**Planning Division – PZ Memo No. 14-035**

**DATE:** MAY 7, 2014  
**TO:** PLANNING AND ZONING COMMISSION  
**THRU:** JEFF KURTZ, PLANNING ADMINISTRATOR *[Signature]*  
**FROM:** KEVIN MAYO, PLANNING MANAGER *[Initials]*  
**SUBJECT:** PDP14-0004 CHUCK E CHEESE'S

**Request:** Preliminary Development Plan (PDP) approval for the site layout and building architecture for a new restaurant

EXTERIOR ELEVATIONS

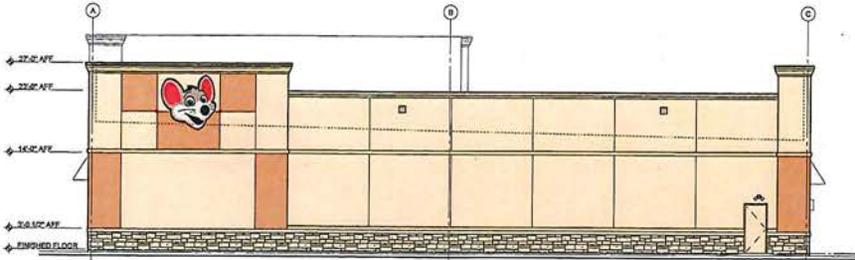
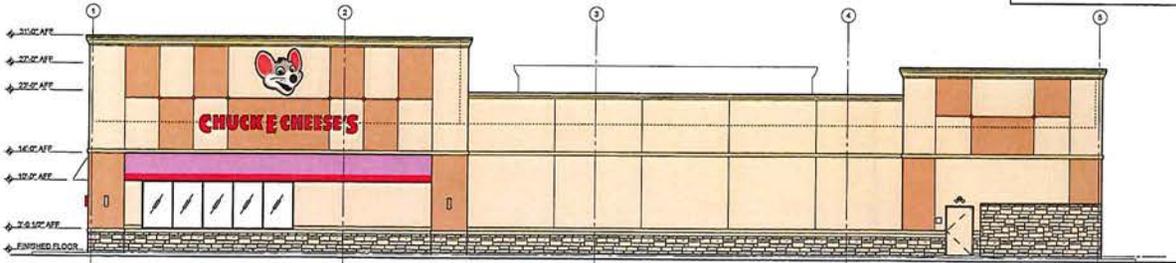
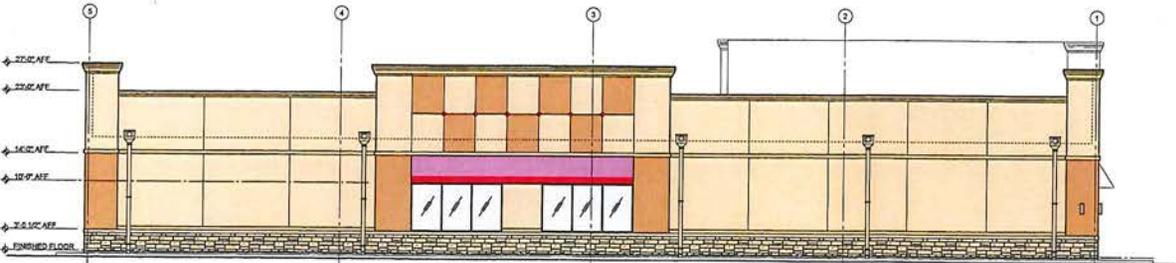
The request includes a comprehensive sign package. Building mounted signage includes individual mounted led internally illuminated pan channel lettering and logo. The booklet includes a detail identifying the manner in which the underside of the colored shade awnings is illuminated. The awnings include an egg-crate soffit that provides diffused light to illuminate the pedestrian pathways. Finally, the booklet does include an exhibit indicating the parapet led border illumination around the entry tower element. A condition is included that prohibits this, as the Code does not permit exposed building illumination.

7. Exposed exterior building illumination is prohibited.
